STAFF REPORT
COMMUNITY DEVELOPMENT DEPARTMENT

HEARING DATE: 11/21/2023
TO: Mayor & City Council
FROM: Linda Ritter, Associate Planner
208-884-5533
SUBJECT: Aviation Subdivision FP-2023-0013

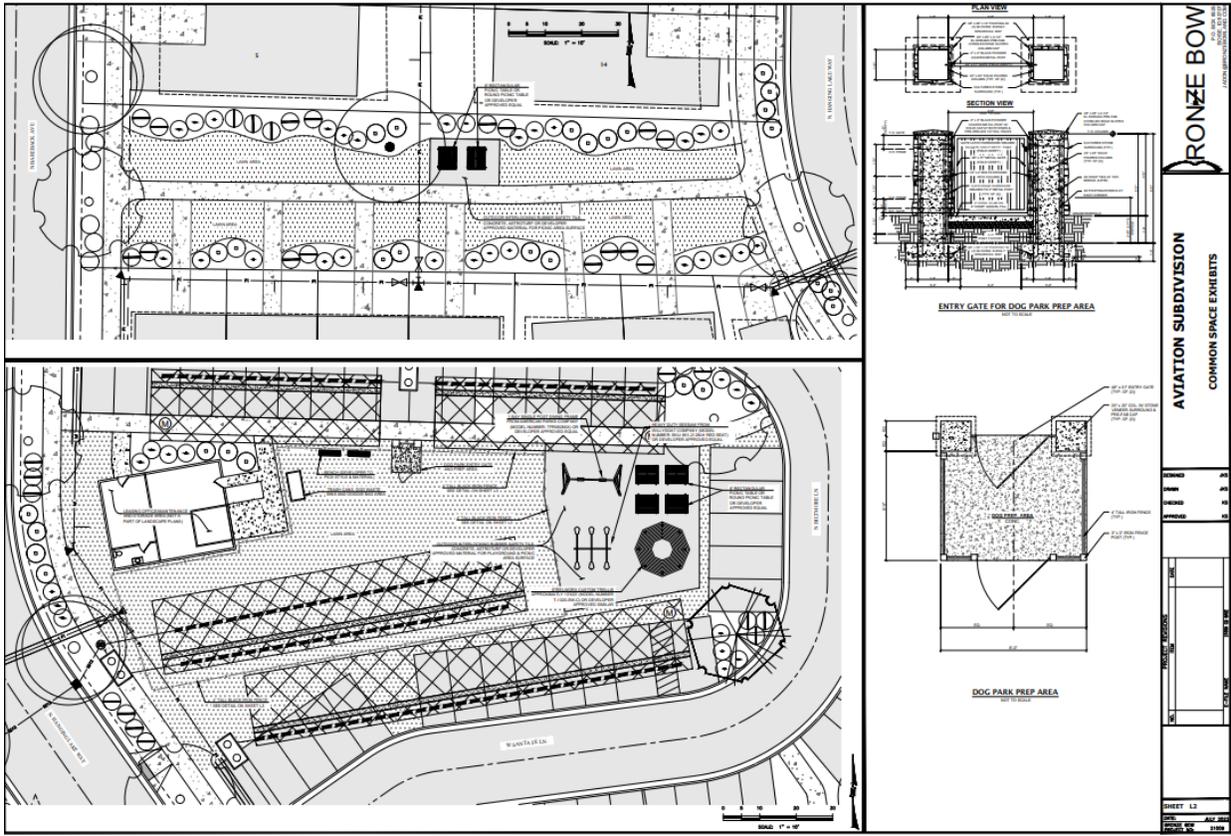
The area on the north side of West Topeka Street, within an easement granted to the Nampa & Meridian Irrigation District (NMID). Historically NMID has not permit trees within their easements. Due to this restriction, the applicant is making a request to exclude this area from the total required tree landscaping calculations. Instead, they propose utilizing it as a grassy area, which aligns with NMID's restrictions and is practical considering the historical context.
